IN THE DRAWINGS**Please amend the drawings as follows:**

Response to 4-15-03 Office Action
Serial No. 10/003,589
Page 13

Title: Vehicle Body with Integral Storage Area and Deck
Serial No. 10/003,589/Inventor: Timothy Williams
Attorney Docket No. 08152-00134

FIG. 1

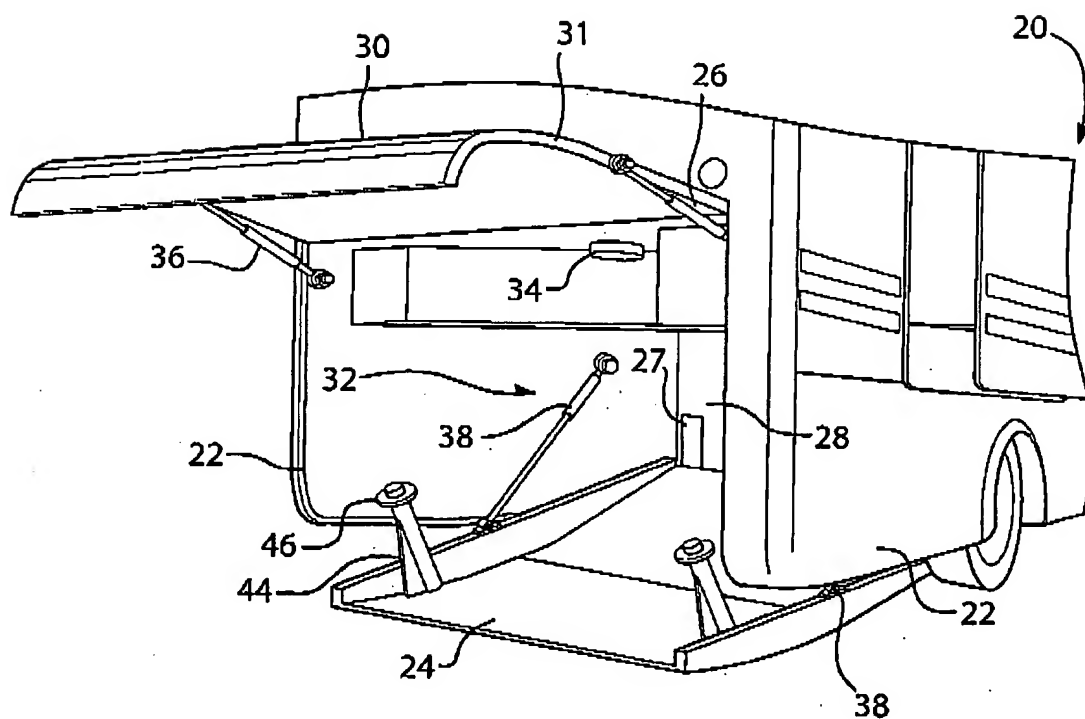
Replace sheets 1-3 of the original drawing sheets with the attached replacement drawing sheets 1-5. Figure 1 has been amended to include an access door 27, hydraulic lift cylinders 38, and hatch edge 31. Access door 27 was included in the original specification on page 7, line 14 and in claim 18. Therefore, the addition to the drawings of access door 27 does not add new matter to the application. Hydraulic lift cylinders 38 are shown in the original drawings as well as the specification and claims and therefore do not present new matter. The hatch edge 31 was disclosed in the specification on page 7, line 20 and has been added to Figure 1 with a reference number for further clarity and also does not add new matter.

FIG. 2

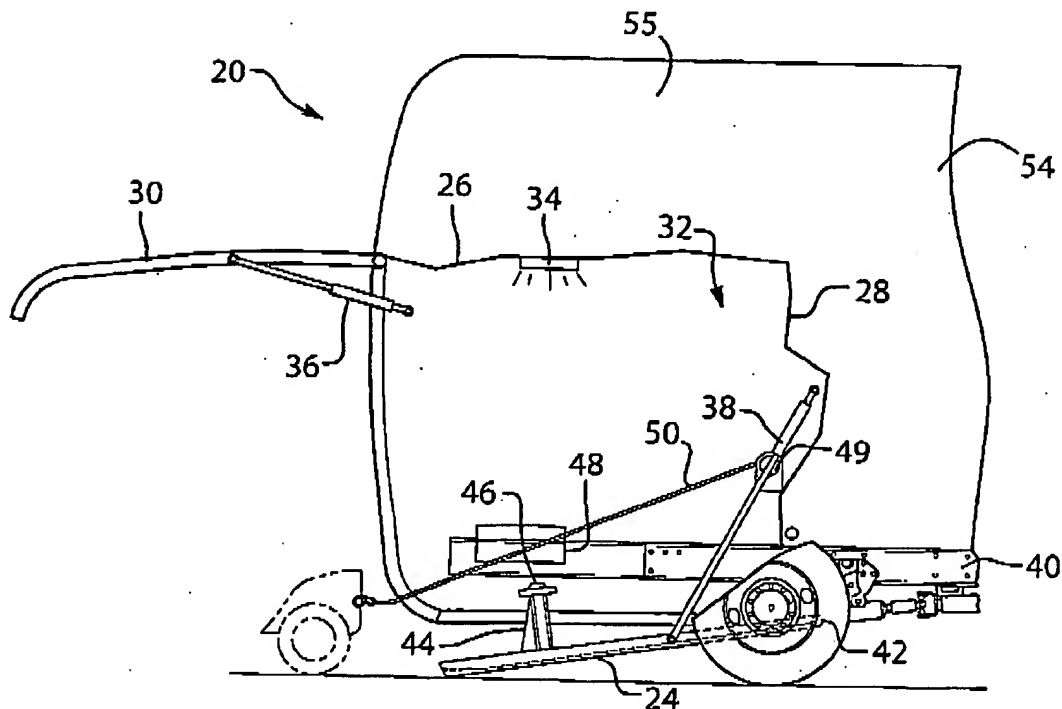
Figures 2 and 3 have been amended to include reference numbers 55 and 49 and to correctly identify reference number 50. Reference number 55 was added to the drawings to identify the additional storage space above the storage compartment as disclosed in original claims 15 and 18. Reference number 49 was added to indicate the winch device and reference number 50 has been amended to correctly identify the cable. Both the winch device and cable were disclosed in the original specification on page 8 lines 21-23 and therefore are not new matter.

Previous Figures 2, 3 and 5 contained a straight line indicating a view into vehicle 20. This straight line has been replaced with a wavy line to better indicate a cut away view into the vehicle 20 and has been made for clarity purposes.

FIG. 4

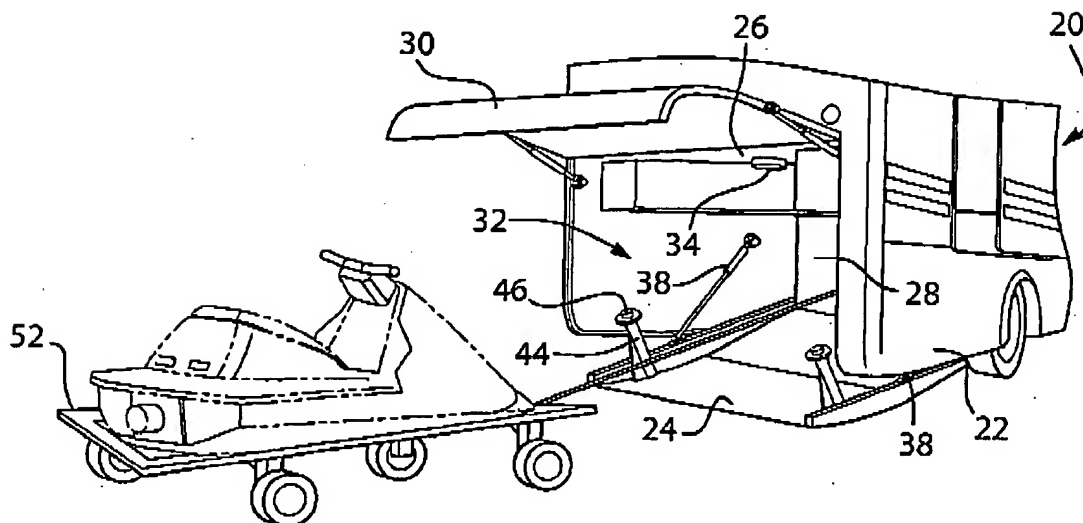
Figure 4 has been amended to add hydraulic lift cylinder 38. Hydraulic lift cylinder 38 was disclosed in the original specification and drawings and has been added to Figure 4 for clarification.

FIG. 6

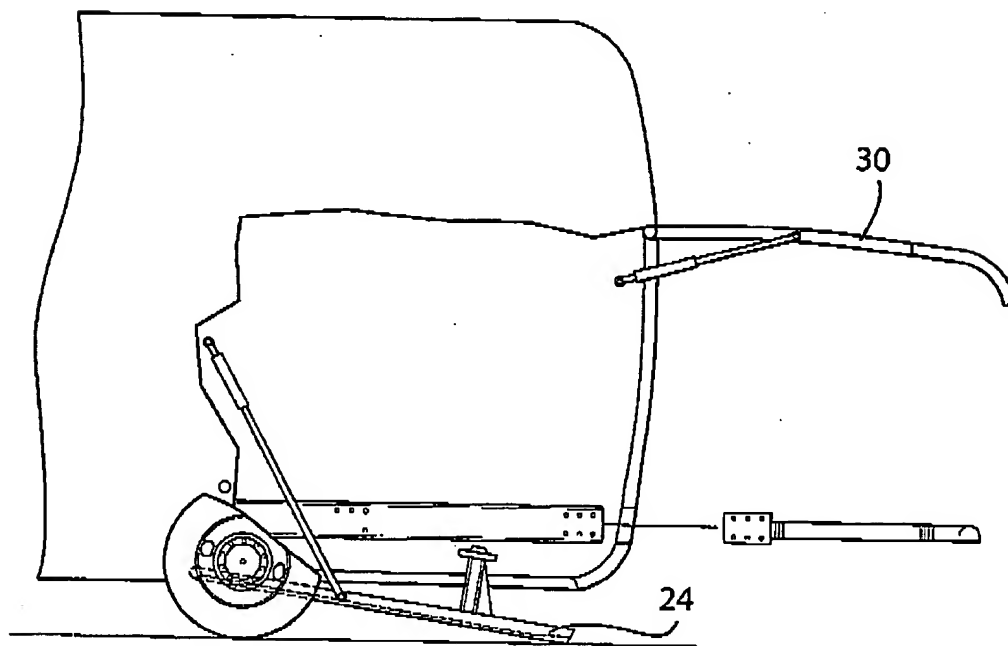
New drawing sheet 4 contains new Figures 6 and 7. Figure 6 has been added to show the hatch located in the front of the vehicle as disclosed in the original specification on page 7, lines 2-5 and original claim 17. Figure 7 has been added to show a second hatch located in an adjacent body panel as disclosed in the original specification on page 7, lines 5-7 and original claim 11. Figures 6 and 7 do not present new matter.
